ADDENDUM NO. 1

State of Maine Ray Building Renovation
28 Tyson Drive
Augusta, ME

April 13, 2022

From: Wood
Environment & Infrastructure Solutions
511 Congress Street
Portland, Maine 04101

A1 CABINETS
 1 1/2" = 1'-0"

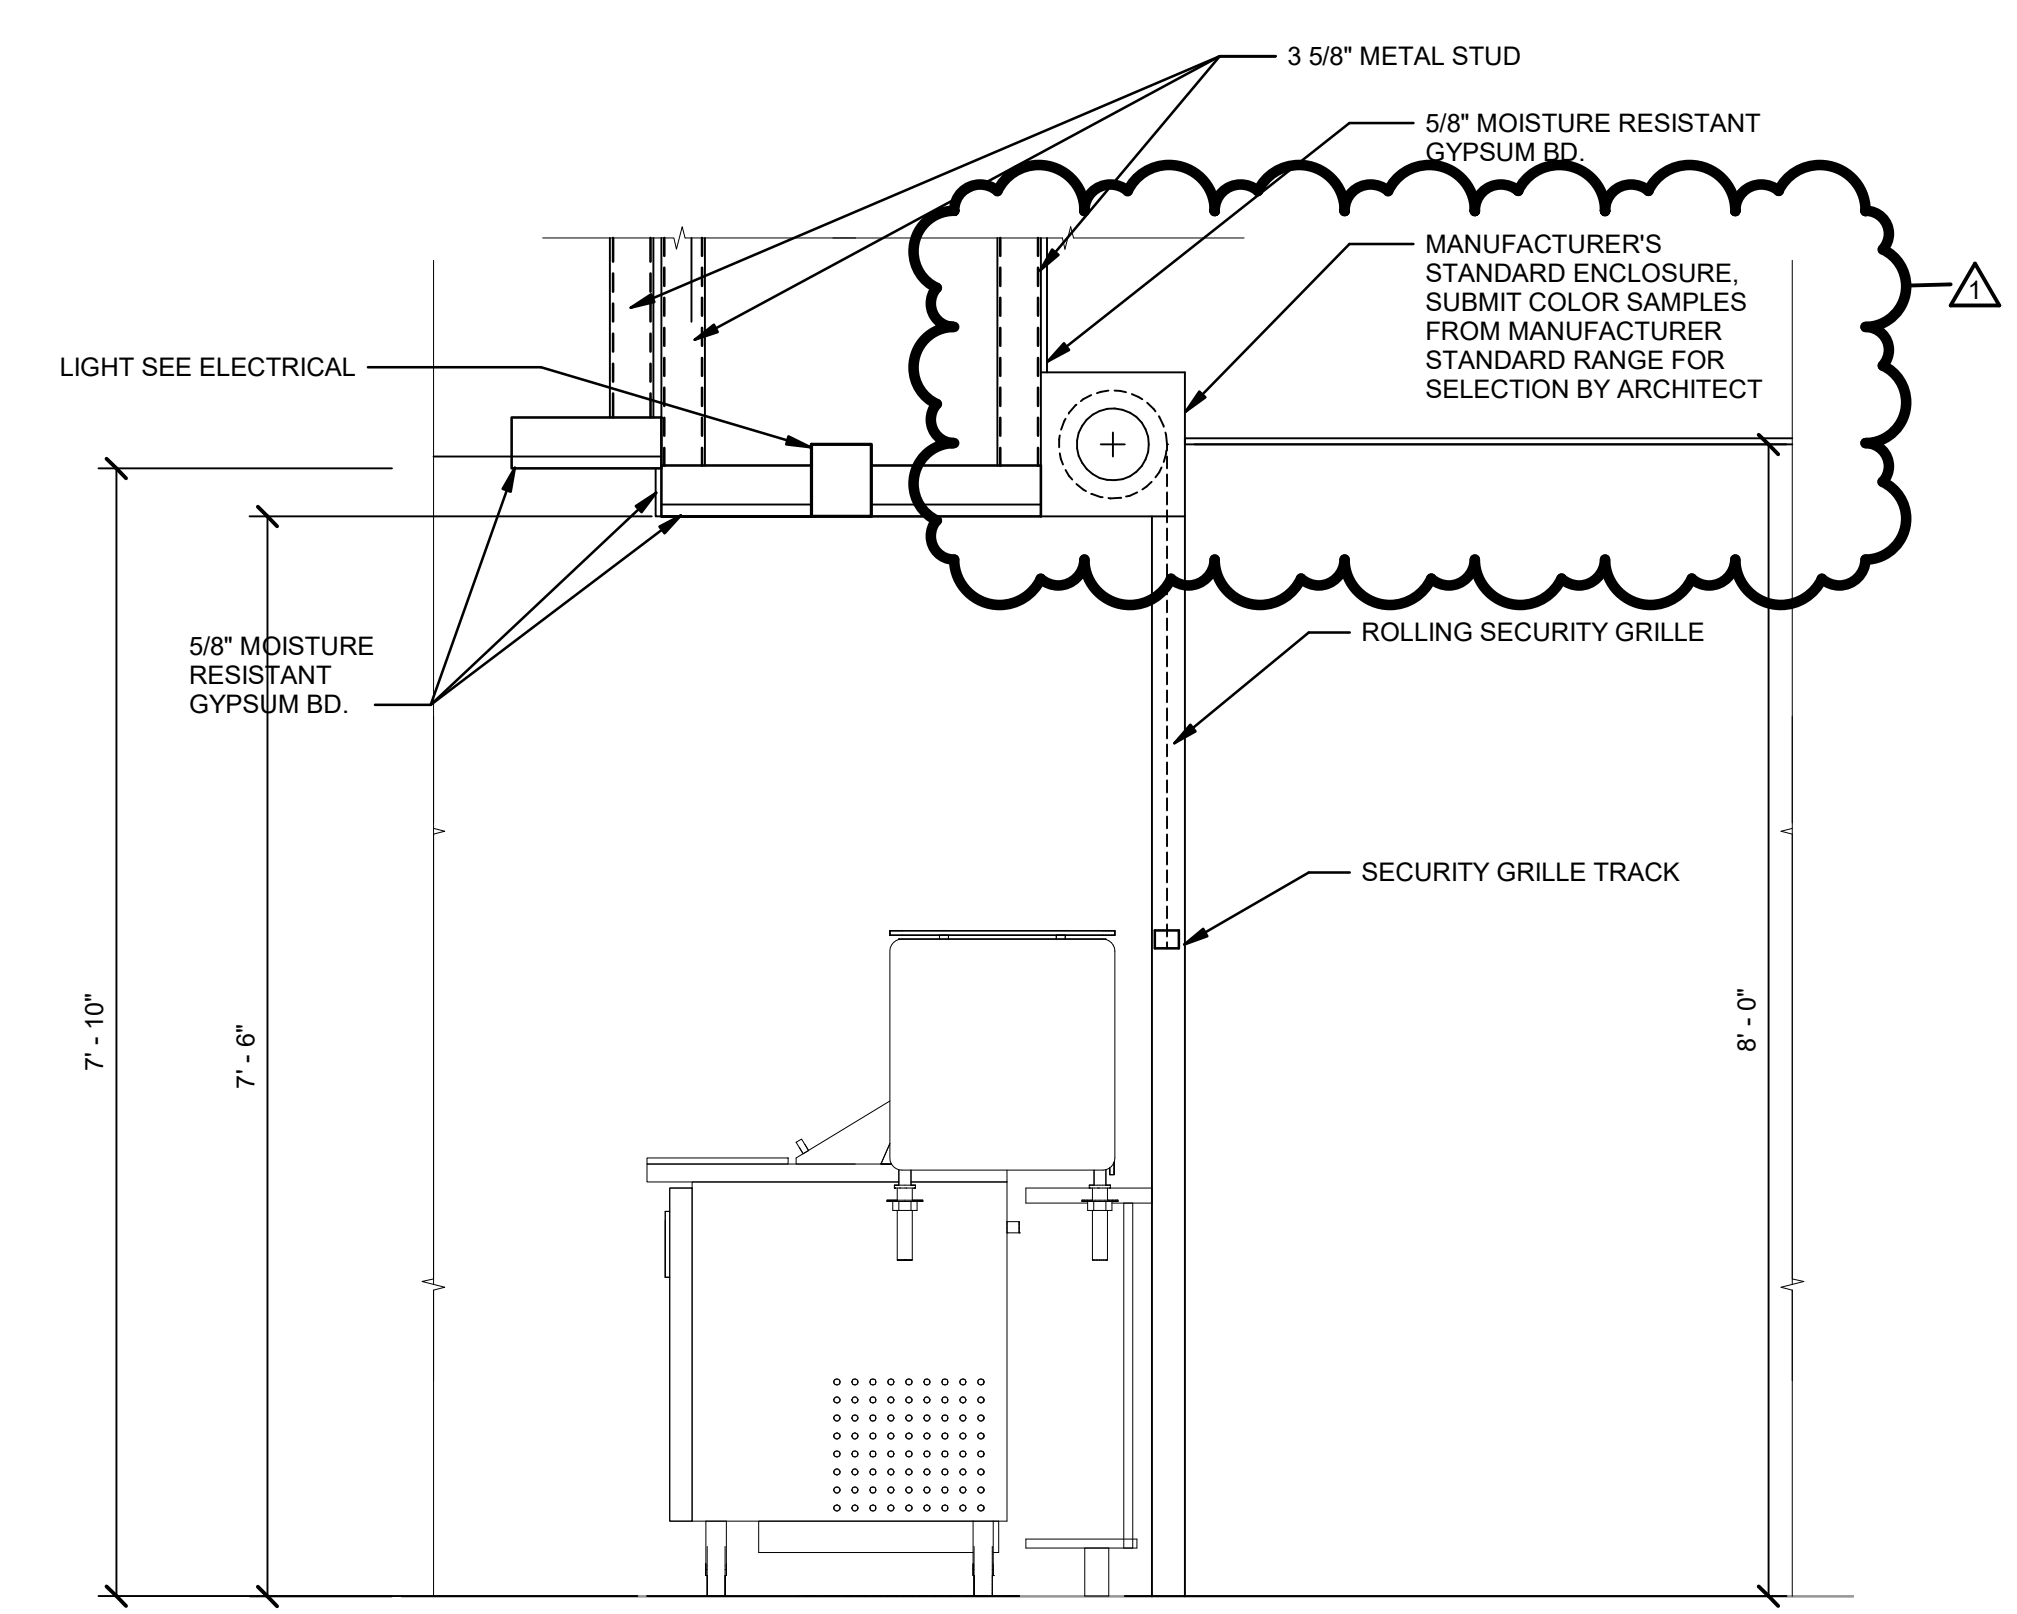
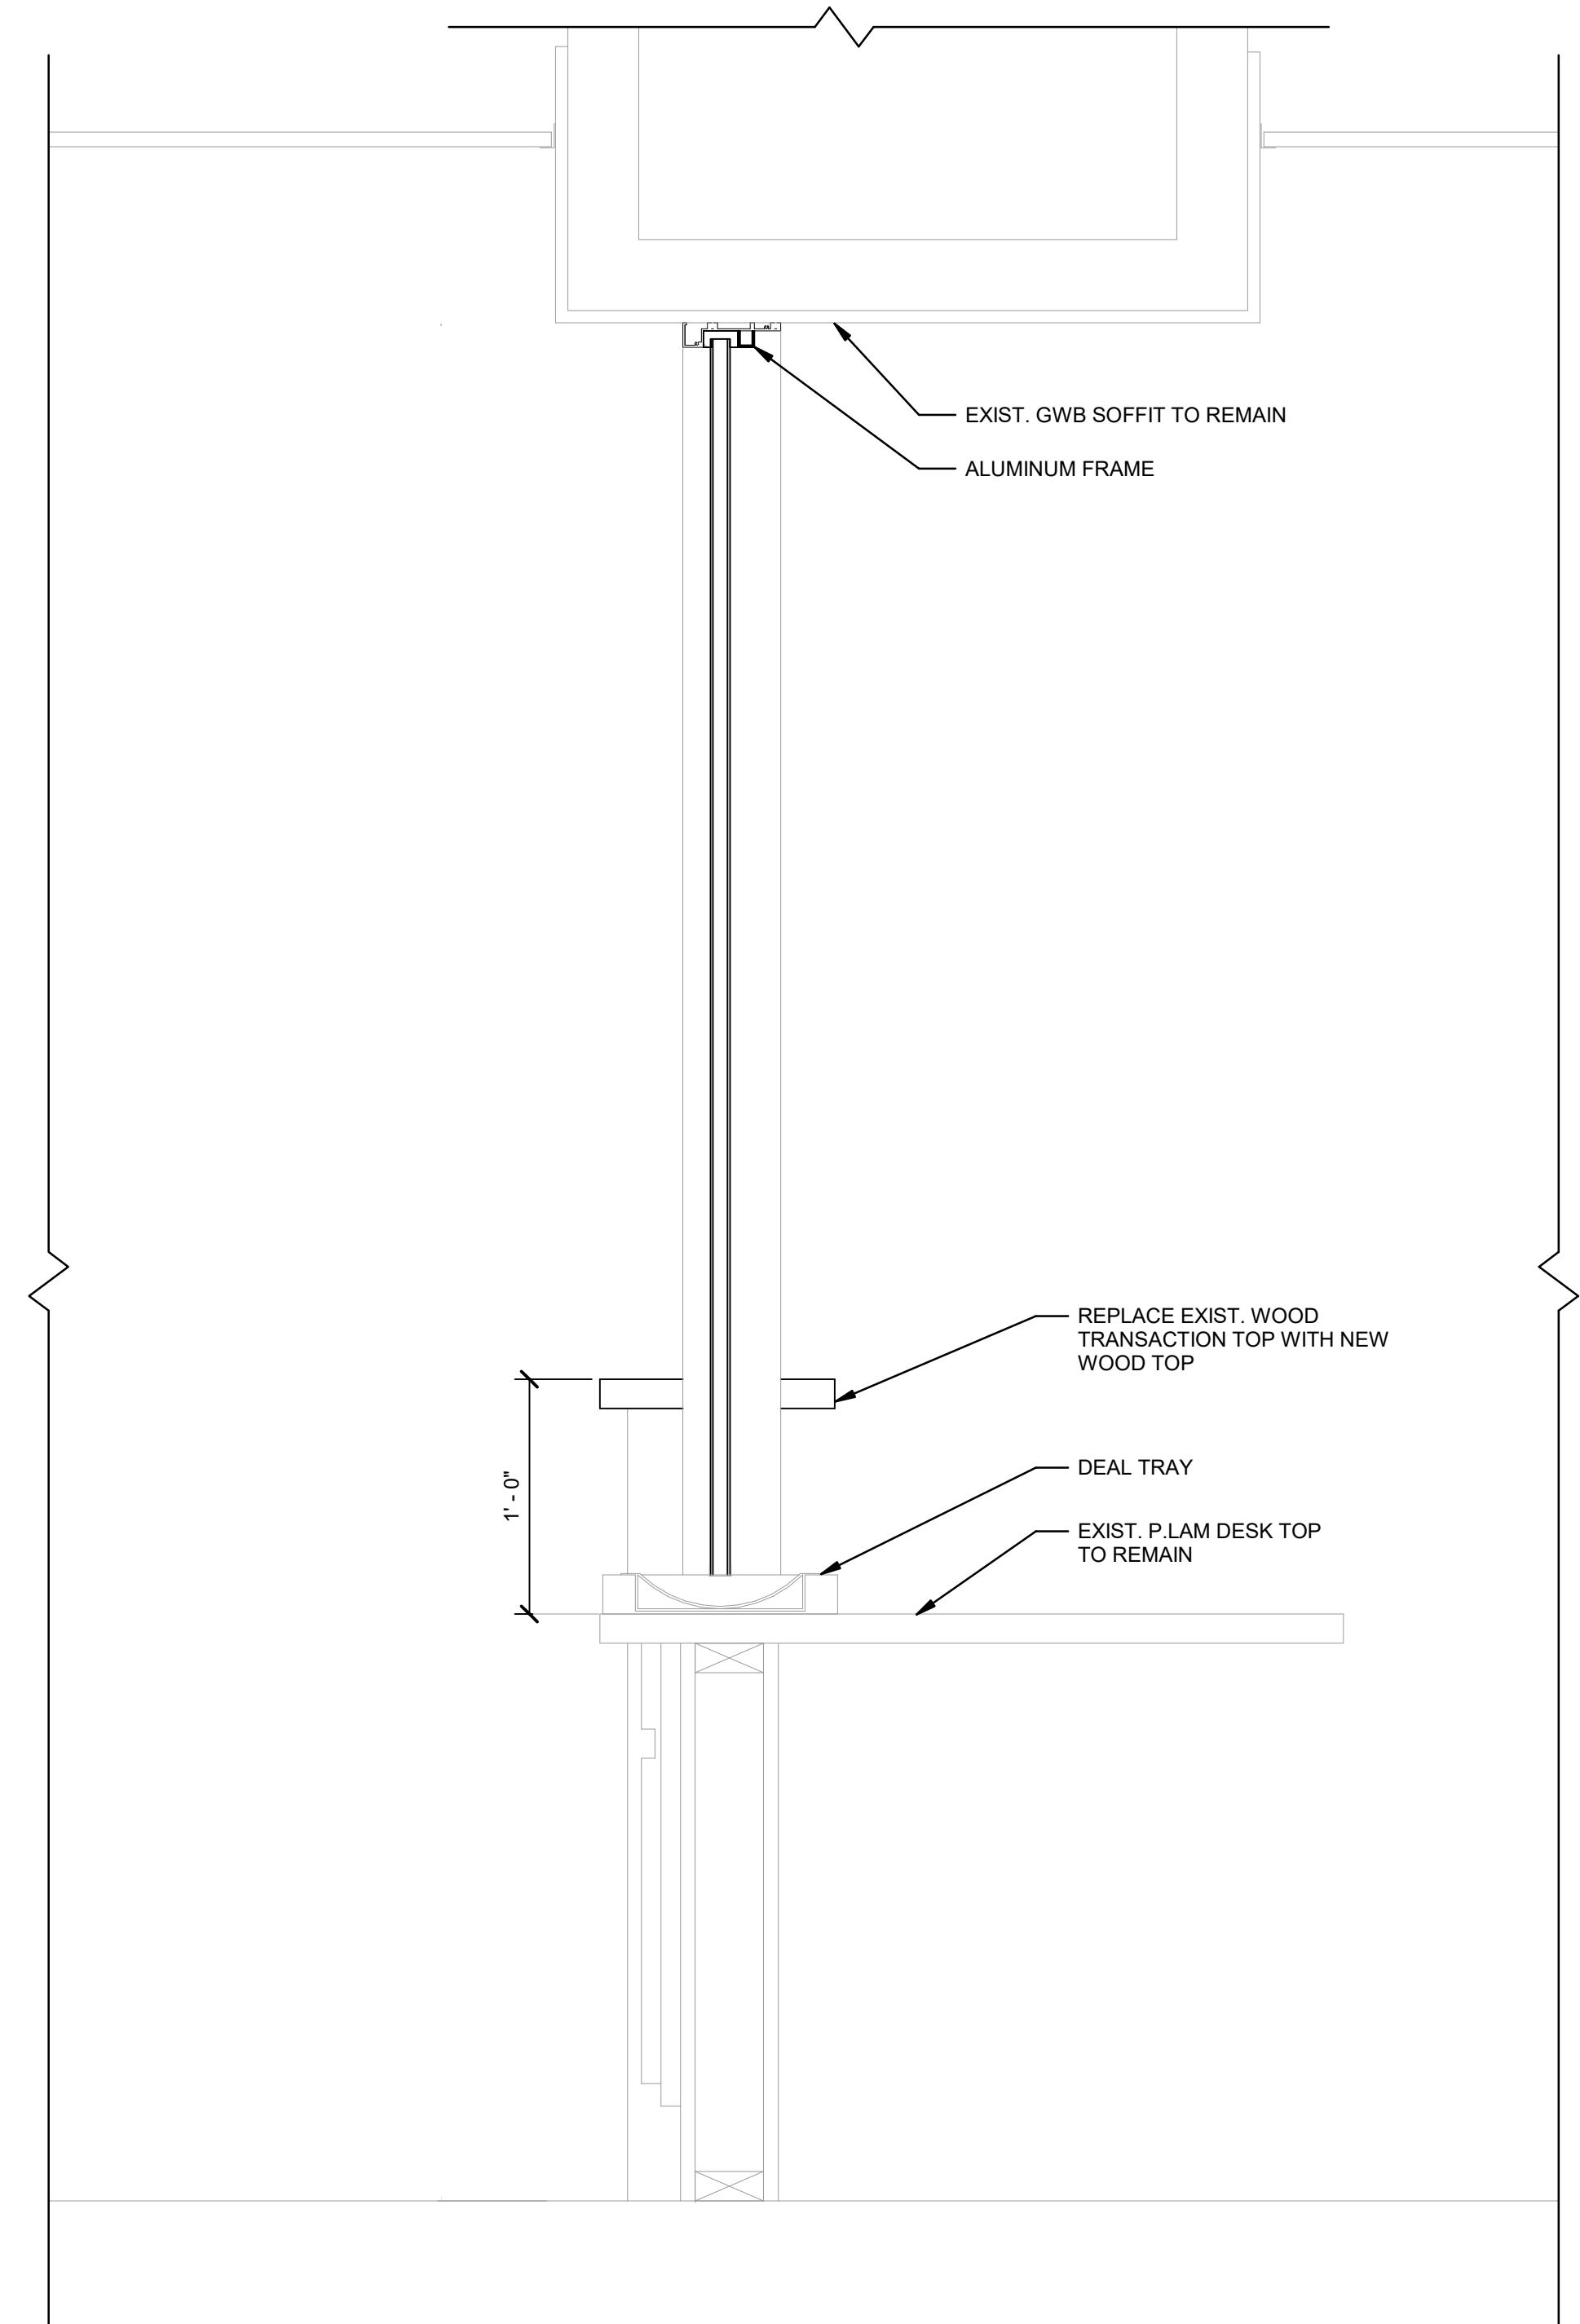
1. REPLACE drawing AE521 with the attached revision dated 04-13-2022. Soffit was removed from around the coiling door hood per RFI#
